Objection — 2A Holmesdale Road (HGY/2026/0977)

Taken from 210608_2A Holmesdale Road London N6 5TQ_Drawings – annotated by myself

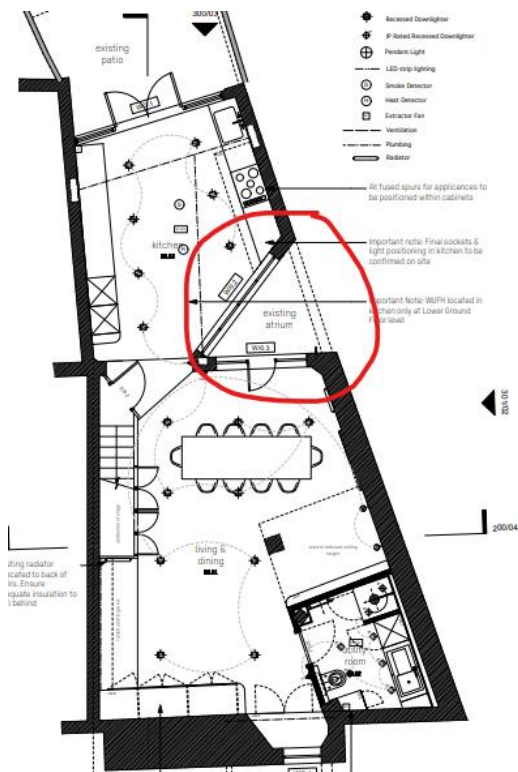
The proposed extension has a 3m high flat-roof parapet. Reading the submitted drawings, it appears to sit at the same absolute height as our own 2.6m high kitchen extension parapet — which is roughly 700mm above the top of the atrium wall. So the proposal would place a solid wall 700mm higher than the existing atrium wall, immediately on the other side of it, along the full length of the boundary the atrium runs alongside.

The effect on daylight is that the band of sky currently visible above the boundary wall — from inside both rooms — becomes brick. For the lower-ground dining room, that's the only sky it can see.

The application's Design and Access Statement says at §5.1 that the daylight and sunlight impact is "expected to be minimal", but I can't see that the atrium has been considered anywhere in the submission. It isn't mentioned in the DAS or the Heritage Statement, no section drawing crosses the boundary at this point, and no daylight or sunlight assessment has been provided.

What I would ask for your consideration is that the parapet on the section of boundary adjacent to our atrium be set no higher than the top of the existing atrium wall. That preserves the existing sky access while leaving the rest of the extension as proposed. I am hoping that is workable yet will still provide our neighbours with sufficient ceiling height for their extension.
